Staff Report – Plan Commission

Docket #:	PC2023-070	Hearing Date:	December 11, 2023
Address:	718 N US 31		
Applicant:	Andrew Barkocy, Barkocy Surveying, Inc.		
Owner:	Shiv Real Estate 44 LLC		
Staff Contact:	Gabe Nelson, nelsong@greenwood.in.gov, 317.887.5230

Project 718 N. US 31 - Subway/Biggby Coffee

PROPOSED SITE

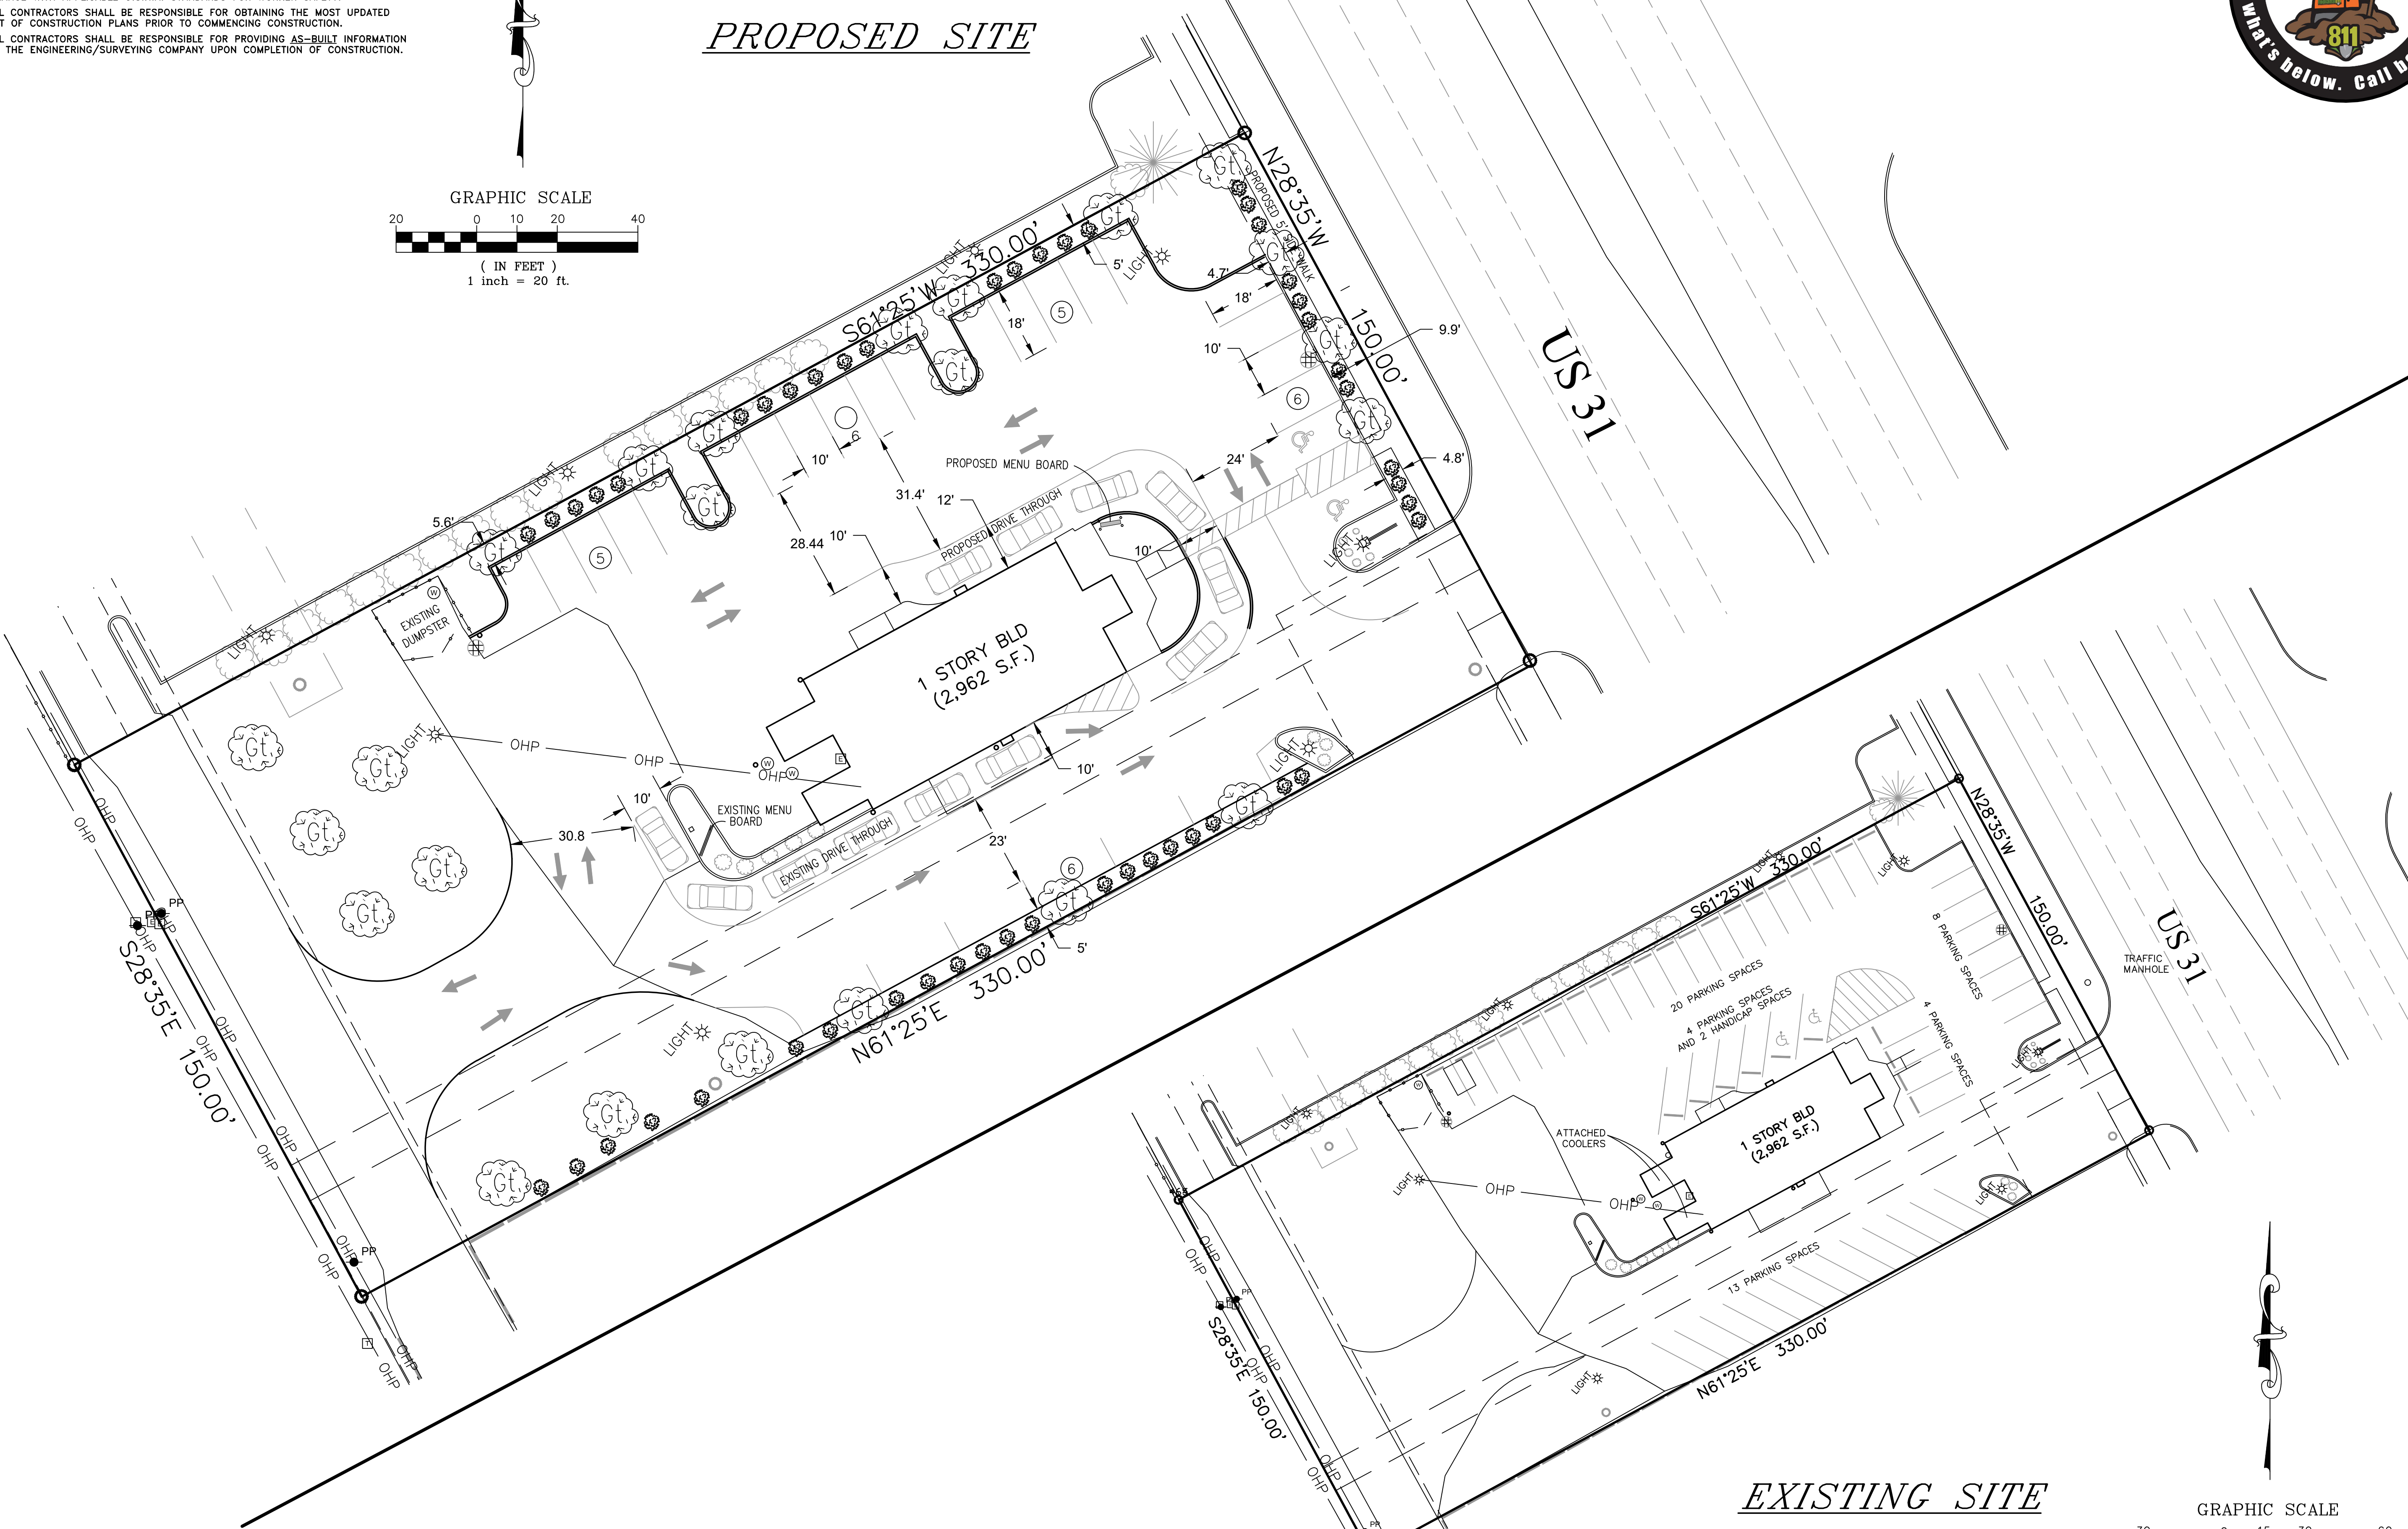
Staff **recommends approval** of Sec 10-03-06 J2d - Perimeter Parking Lot Landscaping. Staff finds this achieves the desired landscaping intent and quantity, while allowing for pedestrian facilities which need to be out of INDOT's SR 135 right-of-way.
